RE: PLANNING PROPOSAL - PP2/21 AT 253-267 PACIFIC HIGHWAY NORTH SYDNEY

I refer to the Planning Proposal at Nos 253-267 Pacific Highway, North Sydney which seeks to amend the North Sydney Local Environmental Plan 2013 (NSLEP 2013) to allow for:-

Extract from PTW plans – red outline showing additional overshadowing

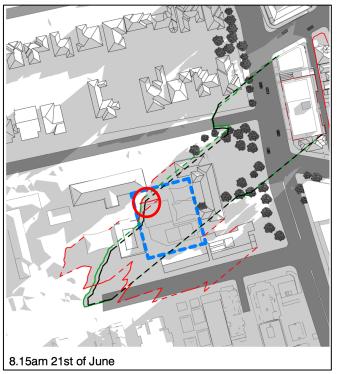
However, the shadow analysis prepared by PTW demonstrate some additional overshadowing beyond the existing school buildings and the projected CPPS shadow during the 8:15am period. It is acknowledged that this will not materially impact on the overall achievement of the required solar access to the playground, however consistent with the CPPS and historical approach no additional shadow to the playground will be supported.

In addition please confirm whether the shadow analysis include the additional 1m as annotated on the plans for roof services.
